Addendum 106 – UN Regulation No. 107

Revision 7 – Amendment 3

08 series of amendments – Date of entry into force: 16 October 2018

Uniform provisions concerning the approval of category M₂ or M₃ vehicles with regard to their general construction

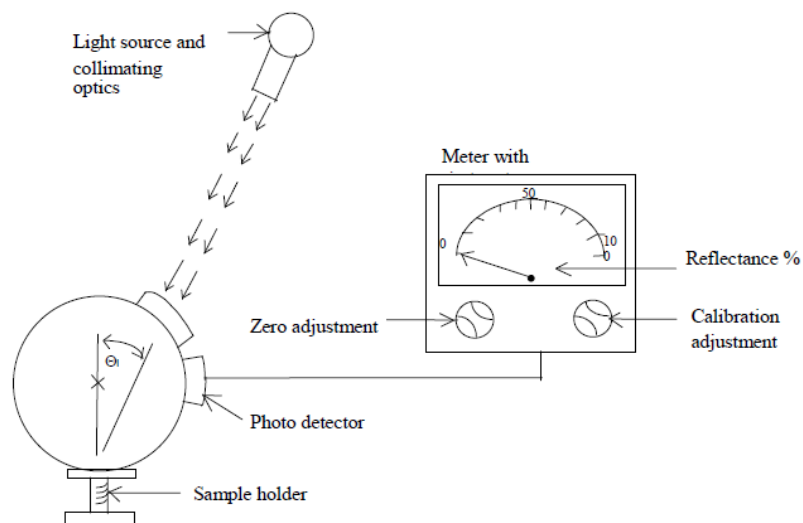
Annex 5, amend to read:

"Annex 5

Requirements to establish the visual contrast per paragraph 3.3.3. of Annex 8

- The visual contrast C shall be established according to the following formula:

- For determination of the reflectance values ρ_1 , ρ_2 and ρ_d an integrating sphere according to CIE 38:1977 shall be used.

The reflectance shall be either read directly from the indicating instrument or calculated according to the following formula:

$$\rho = \frac{\phi_2}{\phi_1}$$

- The illumination angle of the luminous flux of the incident light on the sample Θ_i shall be equal to $8^\circ \pm 0.5^\circ$.
 - The luminous flux of the incident light on the sample shall be determined by using a diffuse reflectance standard calibrated by an accredited laboratory. The extended measurement uncertainty shall be lower than 3 per cent.
- Example of an integrating sphere according to CIE 38:1977:
